# TECH BULLETIN

044  
10/85

SUBJECT: 7001-7023 CPC Regulator Design Change

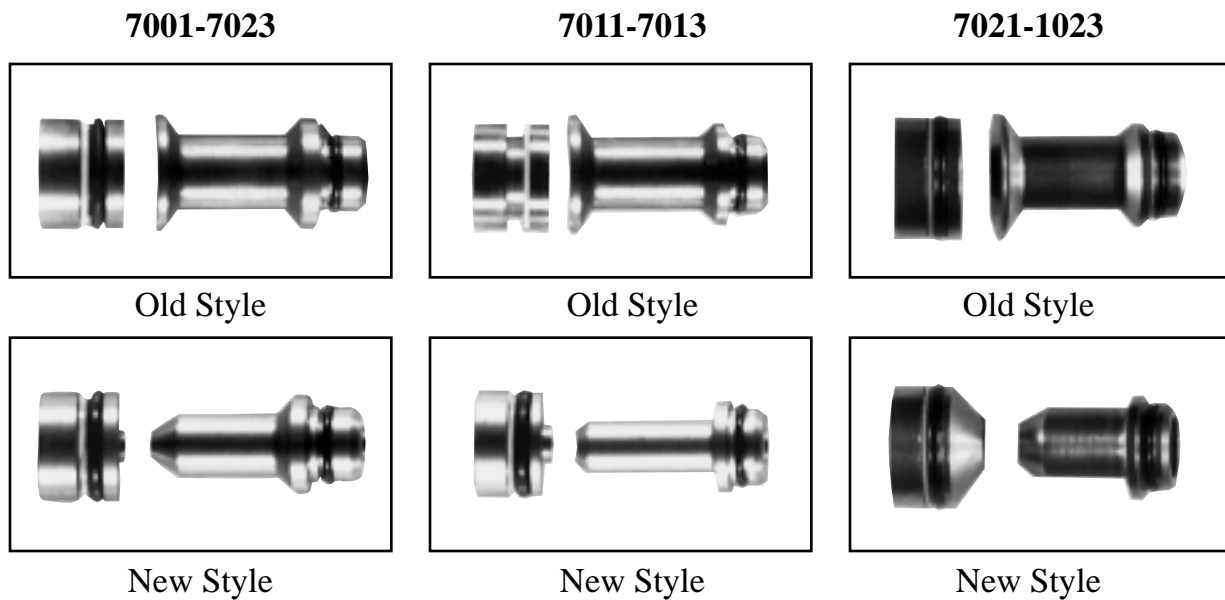
To improve the performance of the CPC Regulator over the full range of specifications, a change was made to the piston and seat.

The change was from a flat seating surface to a tapered or cone-shaped surface. The old and new style parts cannot be interchanged.

Following are effective dates for the three sizes of regulators. If your regulator is stamped with a manufacture date prior to these dates, both the piston and seat should be replaced when the regulator is serviced.

The **old part numbers** have been reassigned to the new tapered piston and seat. Only the **new style** parts will be available and must be replaced as a set. It is also recommended to replace the o-rings when installing a new piston and seat.
